Access Compliance Report

Public Rights-of-Way

(Curb Ramps)

Intersection ID: 13288	Main Street: MAYFAIR_AV	Cross Street: SEYMOUR_DR	Location: W
ADA ID: 805FE9721EE5	Ramp Type: PerpDiag	Initial Pass/Fail: Fail	Overall Compliance: No
Severity Score: 61.25			
Codes/Mitigation Info/Possible Solution		Field Measurements/Component Compliance

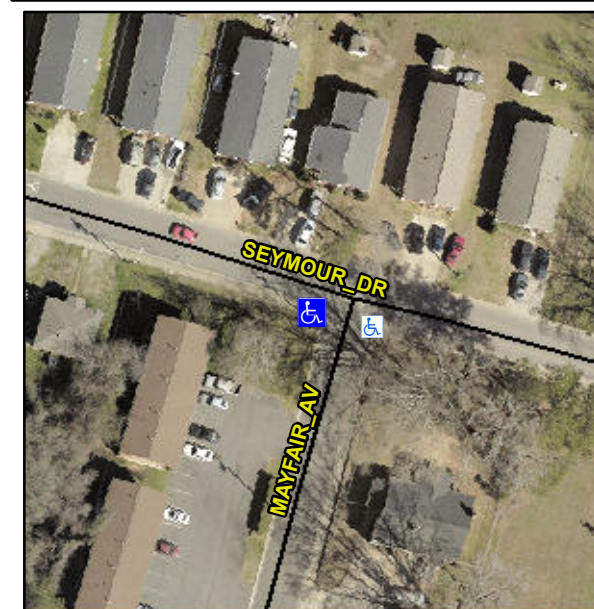
R304.5.1, R304.2.2, R304.5.3

Compliance	Description	Data	Compliance	Description	Data
N/A	Ramp Length (in)	47.0	No	Ramp Slope (%)	12.8
No	Ramp Width (in)	30.0	No	Ramp XSlope (%)	3.8
N/A	Flare Type LT	N/A	N/A	Flare Type RT	N/A
N/A	Flare Slope LT (%)	N/A	N/A	Flare Slope RT (%)	N/A
N/A	Flare Traversable LT?	N/A	N/A	Flare Traversable RT?	N/A
N/A	Landing Length (in)	N/A	N/A	DWS Provided?	N/A
N/A	Landing Width (in)	N/A	N/A	DWS Contrast?	N/A
N/A	Landing Slope (%)	N/A	N/A	DWS Length (in)	N/A
N/A	Landing X Slope (%)	N/A	N/A	DWS Full Width?	N/A
N/A	Landing Curb? (Y/N)	N/A	N/A	DWS Offset (in)	N/A
N/A	Shared Landing?	N/A			
N/A	Gutter Ponding?	N/A	N/A	Gutter Slope (%)	N/A
N/A	Gutter Lip Ht (in)	N/A	N/A	Gutter X Slope (%)	N/A
N/A	Painted X Walk1?	No	N/A	Painted X Walk2?	No
	X Walk 1 Direction	To SE		X Walk 2 Direction	To N
N/A	X Walk 1 Width (in)	N/A	N/A	X Walk 2 Width (in)	N/A
	X Walk 1 Slope (%)	3.5		X Walk 2 Slope (%)	4.8
	X Walk 1 X Slope (%)	0.3		X Walk 2 X Slope (%)	3.6

N/A	Ramp inside XWalk1?	N/A	N/A	Ramp inside XWalk2?	N/A
	Road Slope (%)	2.6	N/A	Clear Space?	N/A
	Road X Slope (%)	7.1	N/A	Clear Space to XWalk (in)	N/A
N/A	Any Obstructions?	N/A	N/A	Storm Grate/Utility Hazard?	N/A
	Obstruction Type			Storm Grate/Utility Type	
		N/A			N/A
			Yes	Surface Condition? (G/P)	Good

Remove & Replace Curb Ramp With Two New Directional Ramps or Equivalent.
